Addendum No. 003

Subject: 2020 Classroom Modernizations
SDP Contract Numbers: B-001 C of 19/20 & B-003 C of 19/20

Location: Francis Scott Key School
2230 S. 8th St, Philadelphia PA 19148

This Addendum, dated February 27, 2020, shall modify and become part of the Contract Documents for the work of this project. Any items not mentioned herein, or affected by, shall be performed strictly in accordance with the original documents.

1 ELECTRICAL FIRST FLOOR POWER PLAN
E2.1 1/8" = 1'-0"

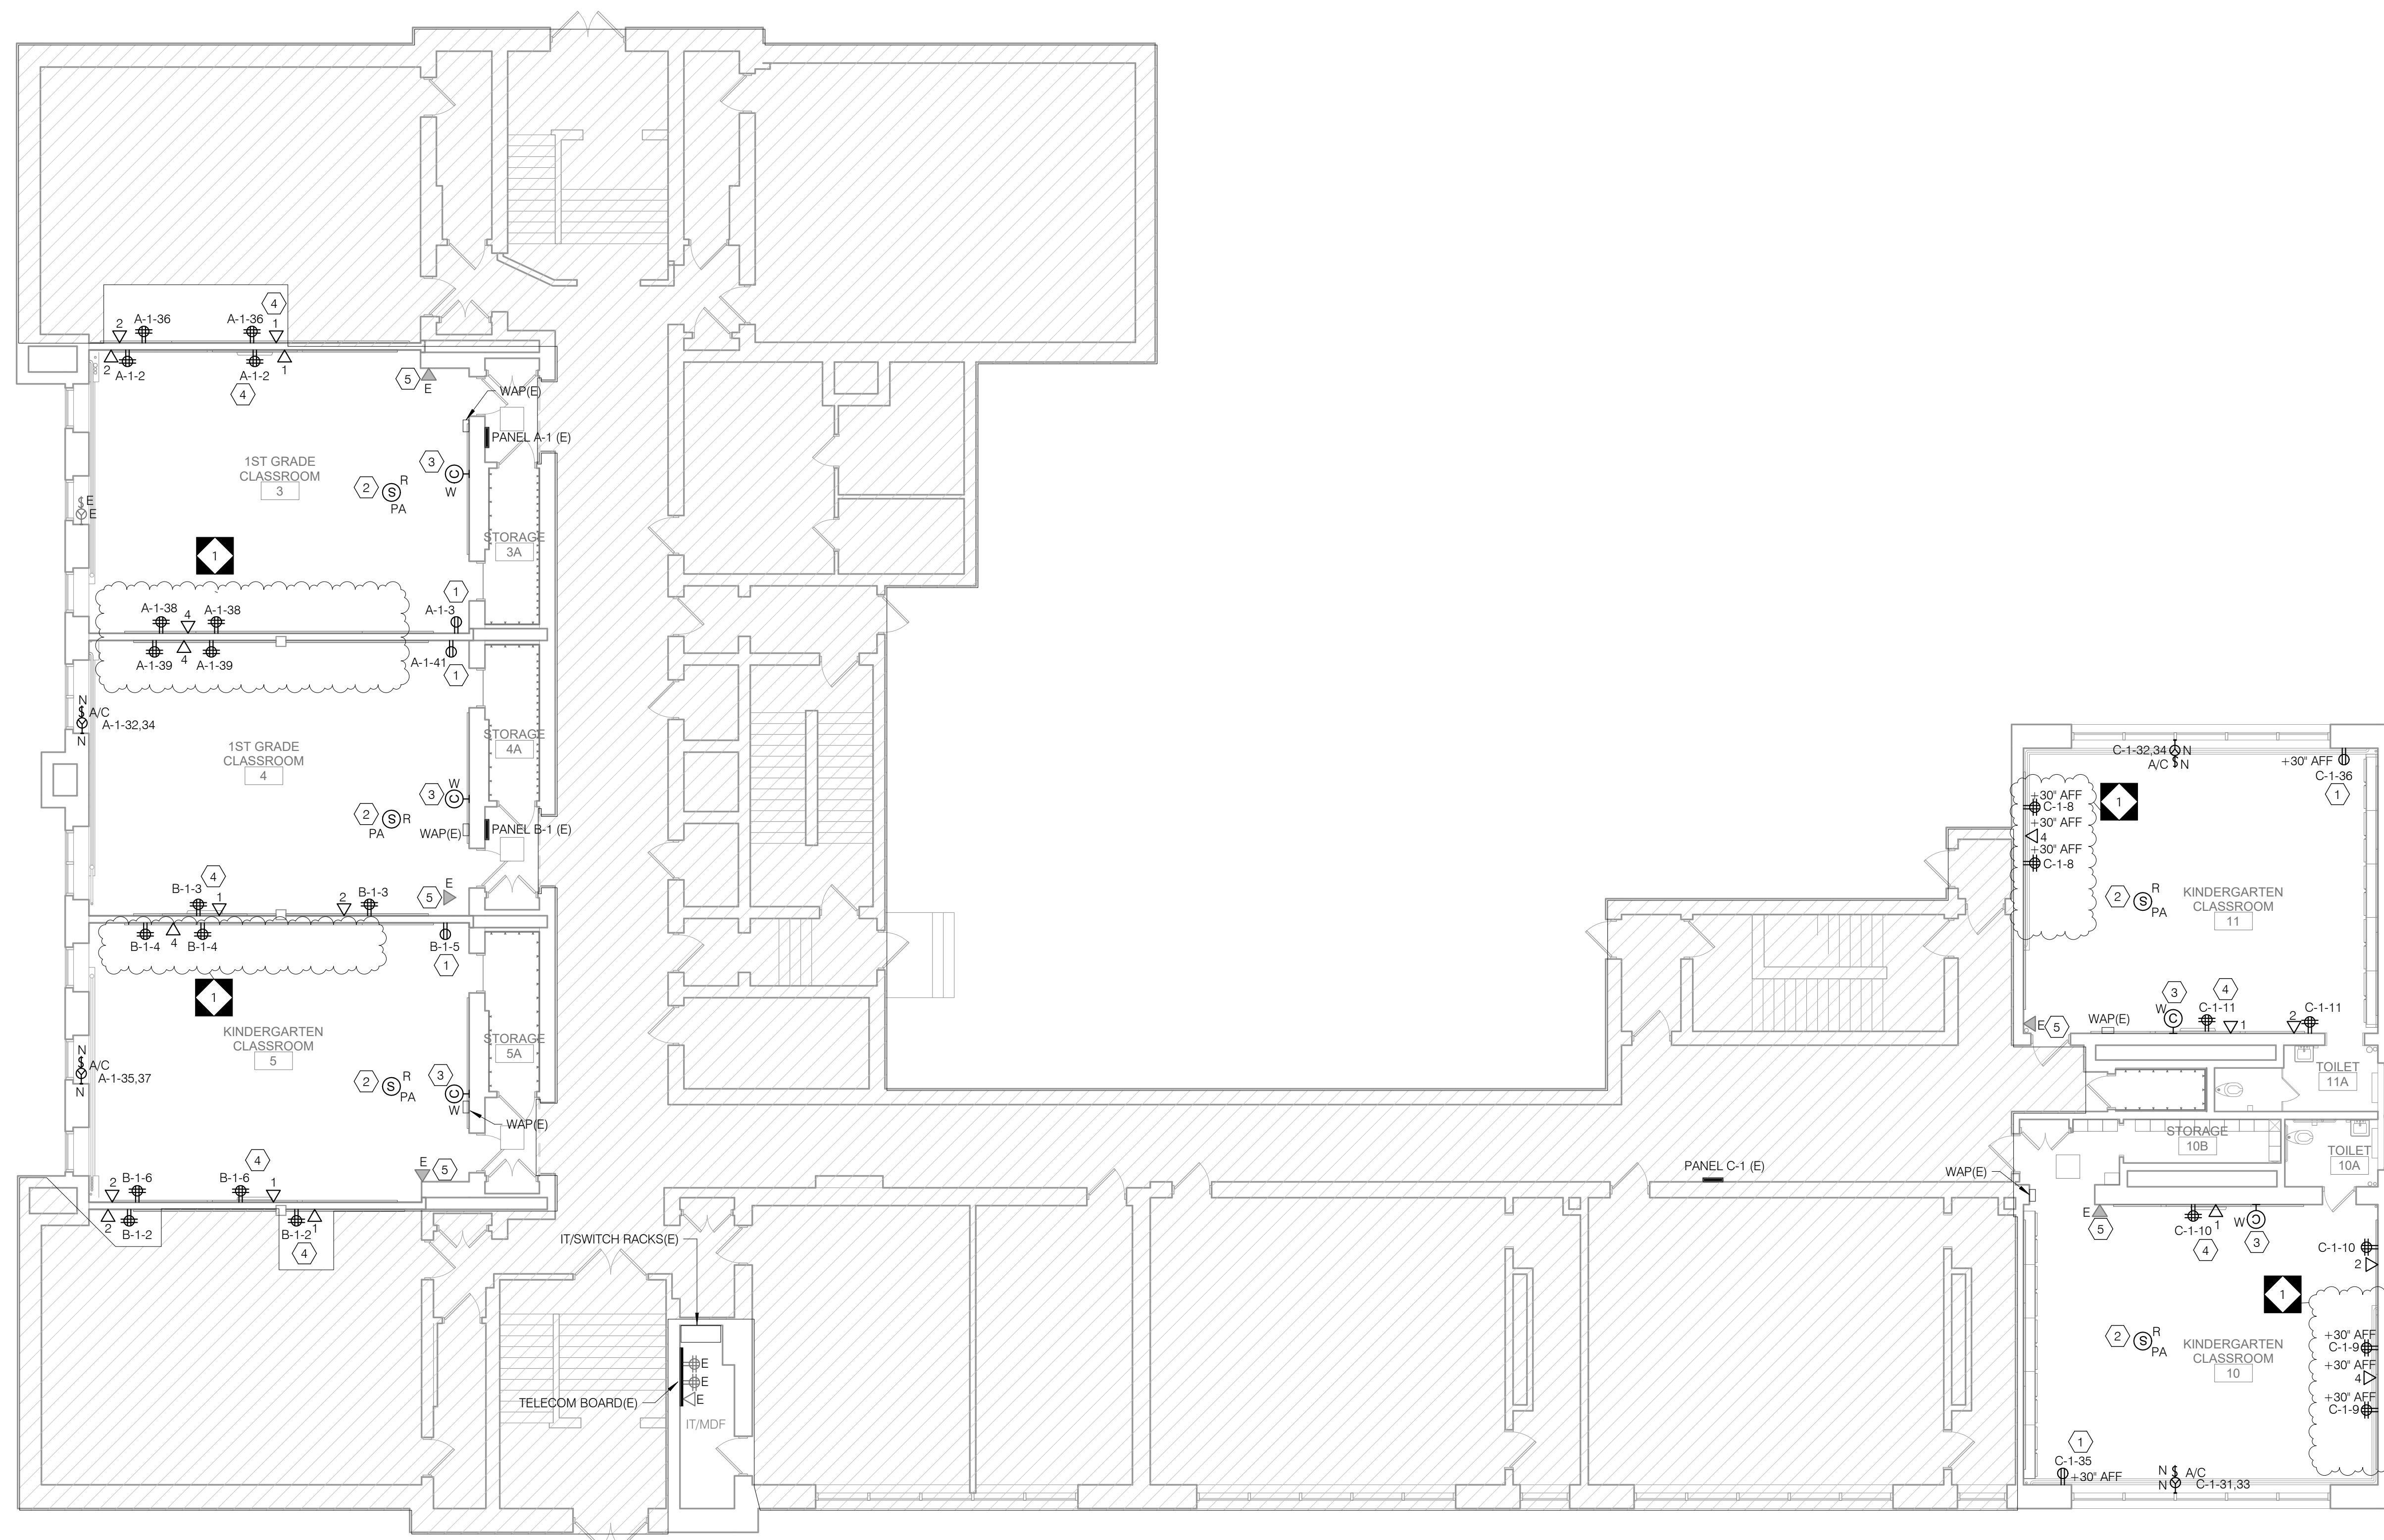
1. ADD General Sheet Note #6 to read "ELECTRICAL CONTRACTOR TO RUN ALL NEW SURFACE MOUNTED CONDUITS AND RACEWAYS 6" FROM CORNERS OF EACH CLASSROOM TO AVOID CONFLICT WITH DISPLAY BOARDS AND OTHER CLASSROOM FURNISHINGS."
2. REVISE power and data layout as indicated on the drawings.

1 ELECTRICAL SECOND FLOOR POWER PLAN
E2.2
1/8" = 1'-0"

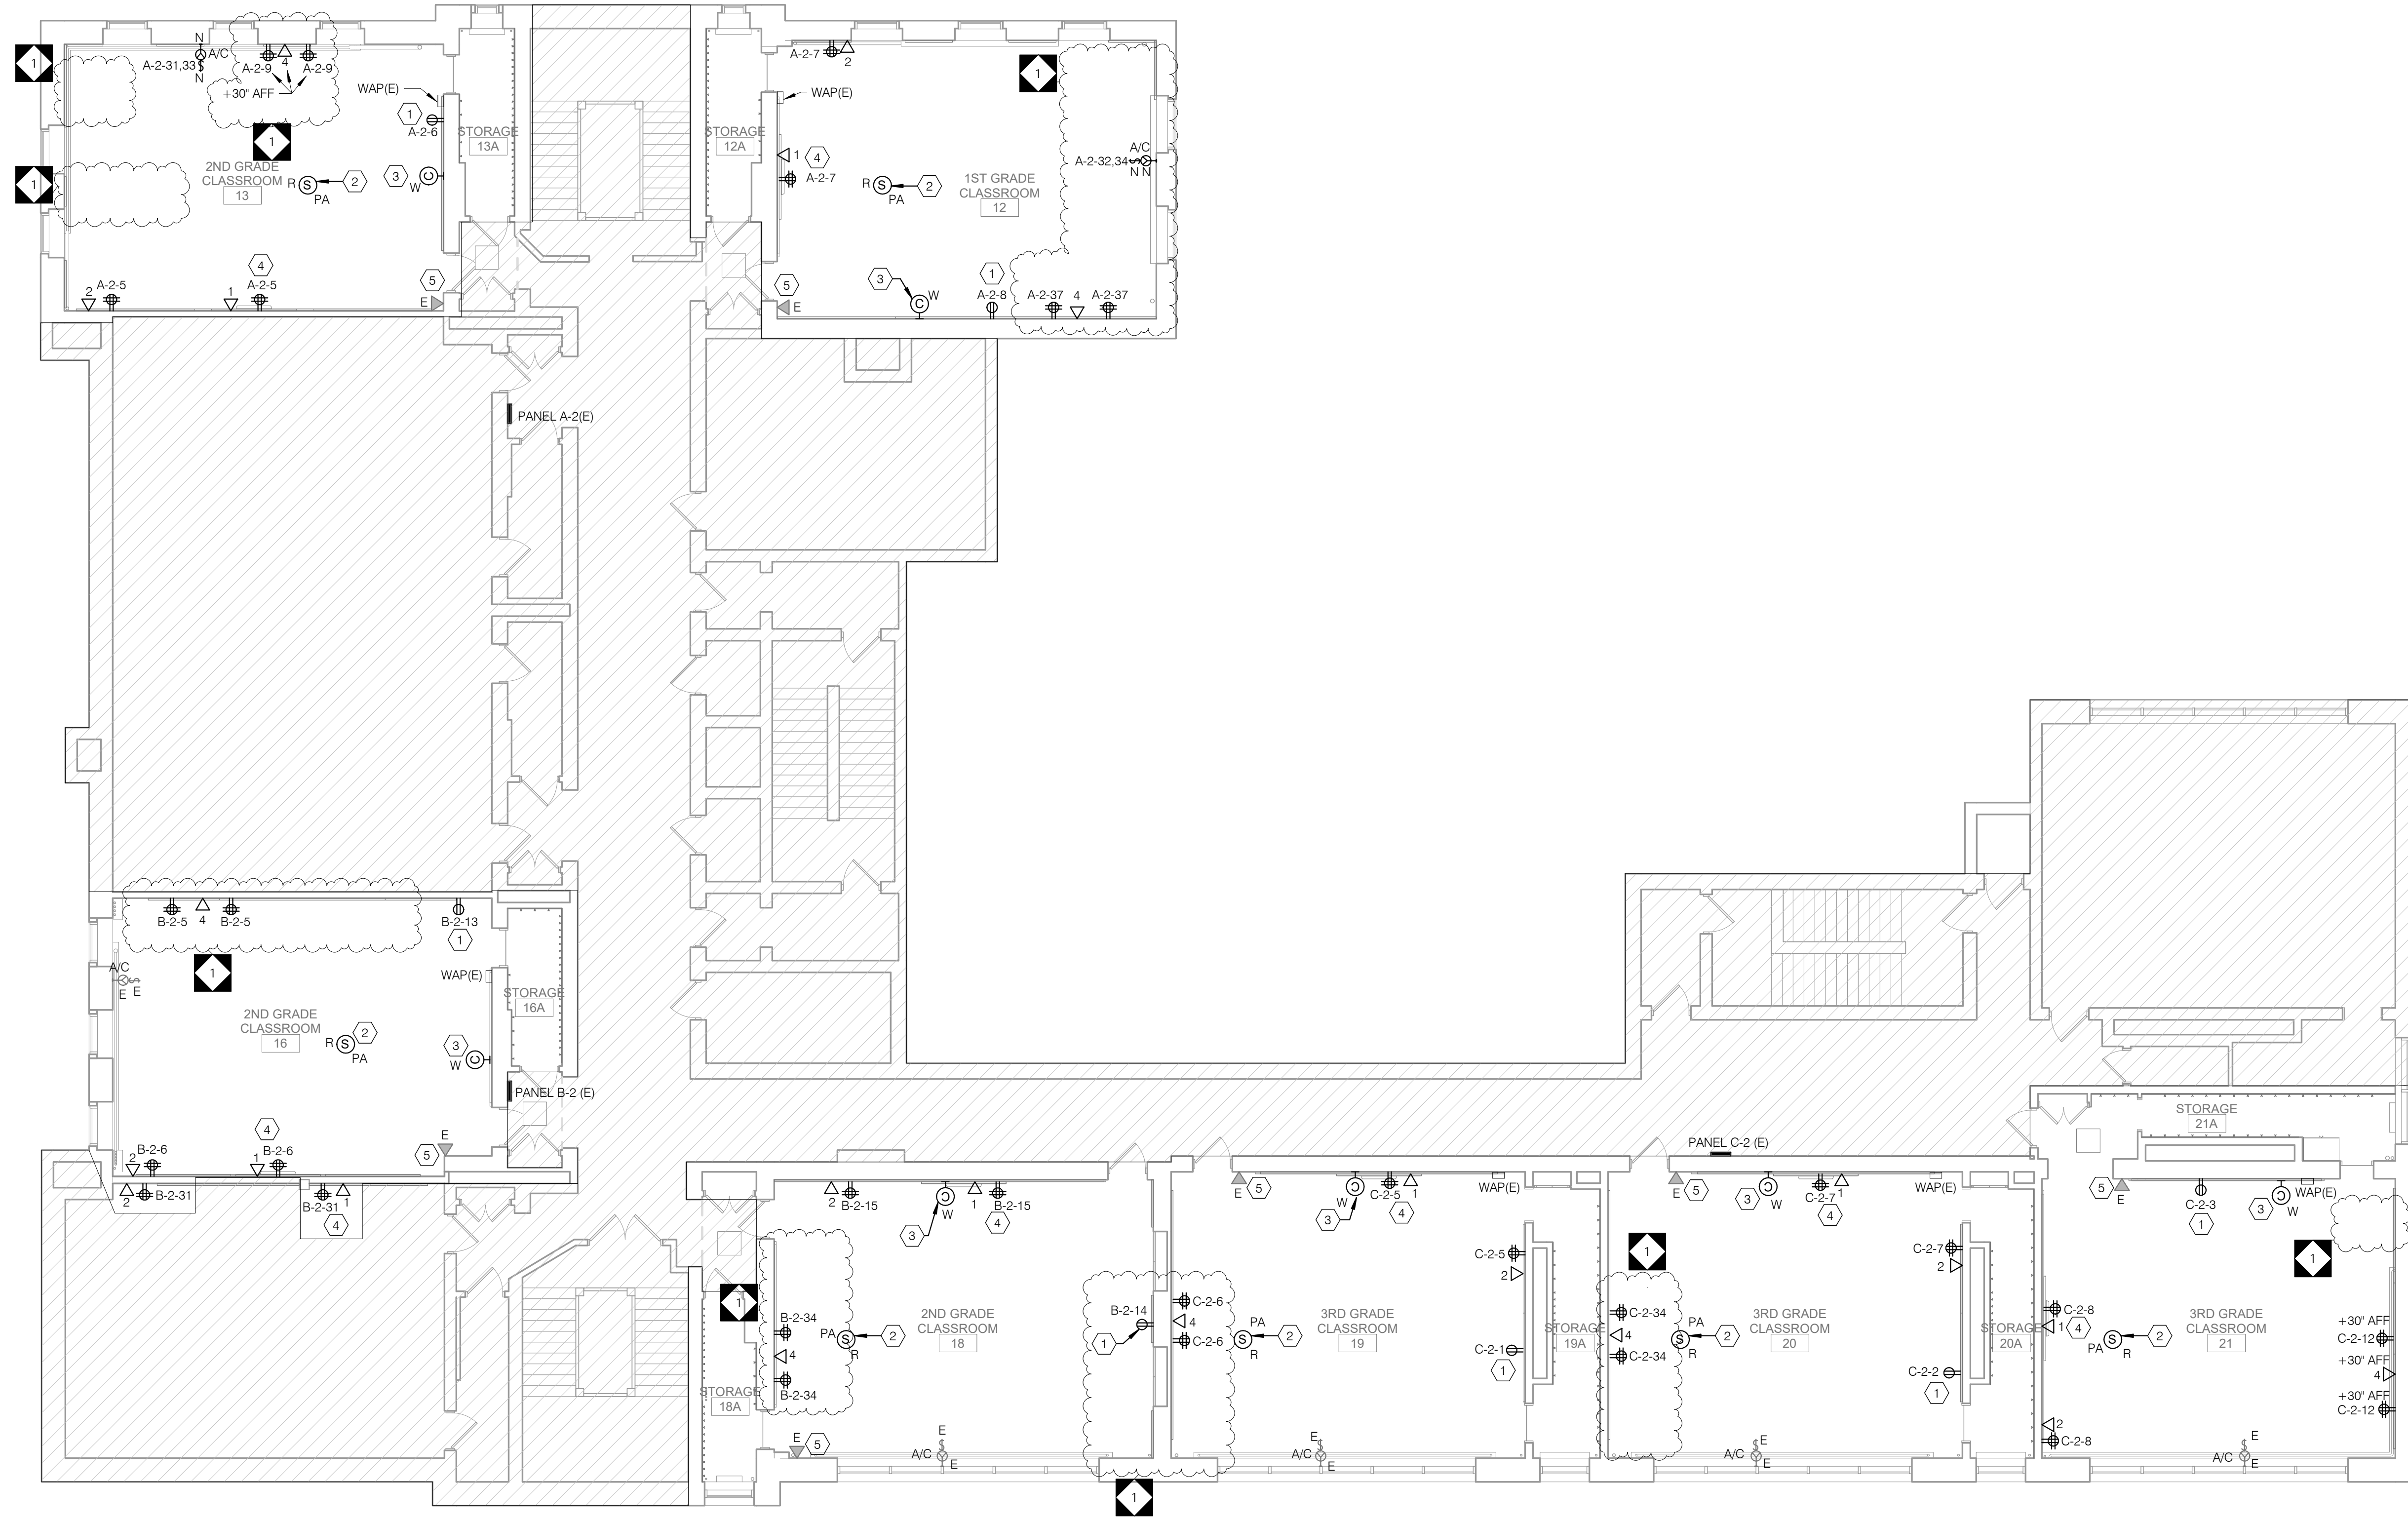
1. ADD General Sheet Note #6 to read "ELECTRICAL CONTRACTOR TO RUN ALL NEW SURFACE MOUNTED CONDUITS AND RACEWAYS 6" FROM CORNERS OF EACH CLASSROOM TO AVOID CONFLICT WITH DISPLAY BOARDS AND OTHER CLASSROOM FURNISHINGS."

2. **REVISE** power and data layout as indicated on the drawings.
